Access Compliance Report Public Rights-of-Way (Curb Ramps)

Main Street: HEDLUND_DR Cross Street: HARLE_AVE Location: SW

ADA ID: RPRK210924111515 Ramp Type: Type 1 - Perpendicular Diagonal Initial Pass/Fail: Fail Overall Compliance: No Severity Score: 15

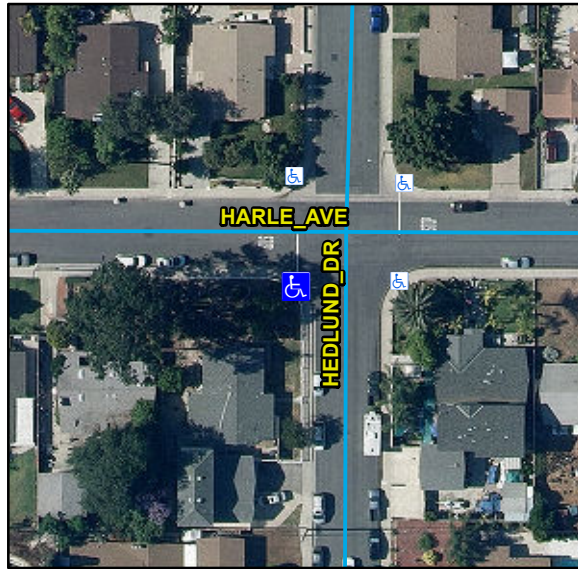
Compliance	Description	Data	Compliance	Description	Data
N/A	Ramp Length (in)	60	N/A	Flare Type LT	
Yes	Ramp Width (in)	48			N/A
No	Ramp Run Slope (%)	11.4	N/A	Flare Slope LT (%)	N/A
Yes	Ramp Cross Slope (%)	0.9	N/A	Flare Traversable LT	N/A
N/A	Landing Present	N/A	N/A	Flare Type RT	
N/A	Landing Length (in)	N/A			N/A
N/A	Landing Width (in)	N/A	N/A	Flare Slope RT (%)	N/A
N/A	Landing Run Slope (%)	N/A	N/A	Flare Traversable RT	N/A
N/A	Landing Cross Slope (%)	N/A	N/A	DWS Provided	N/A
N/A	Landing Movement Obstructed?	N/A	N/A	DWS Contrast	N/A
	Landing Movement Type	N/A	N/A	DWS Length (in)	N/A
N/A	Landing Shared	N/A	N/A	DWS Full Width	N/A
N/A	Clear Space	Yes	N/A	DWS Offset Left (in)	N/A
N/A	Clear Space To Crosswalk (in)	N/A	N/A	DWS Offset Right (in)	N/A
N/A	Marked Crosswalk 1	No	N/A	Marked Crosswalk 2	No
	Crossing 1 Direction	N		Crossing 2 Direction	E
	Marked Crosswalk 1 Width (in)	N/A		Marked Crosswalk 2 Width (in)	N/A

N/A	Ramp Inside Crosswalk 1	N/A	Yes	Ramp Inside Crosswalk 2	N/A
	Crossing 1 Slope (%)	0.4		Crossing 2 Slope (%)	1
	Crossing 1 Cross Slope (%)	2.5		Crossing 2 Cross Slope (%)	4.7
N/A	Gutter Ponding	N/A	No	Curb Slope	9.1
No	Gutter Lip Height (in)	0.5		Road Run Slope (%)	0.3
N/A	Gutter Run Slope (%)	N/A		Road Cross Slope (%)	6.6
N/A	Gutter Cross Slope (%)	N/A			
Yes	Overall Surface Condition: Acceptable		Yes	Perp Joint Present	Yes
	Cross Gutter Present?	No		Spandrel Present?	No
	Replace Cross Gutter?	N/A		Replace Spandrel?	N/A

Remove & Replace Curb Ramp With Two New Directional Ramps or Equivalent.

R304.2.2, R302.7.2, STD 1115
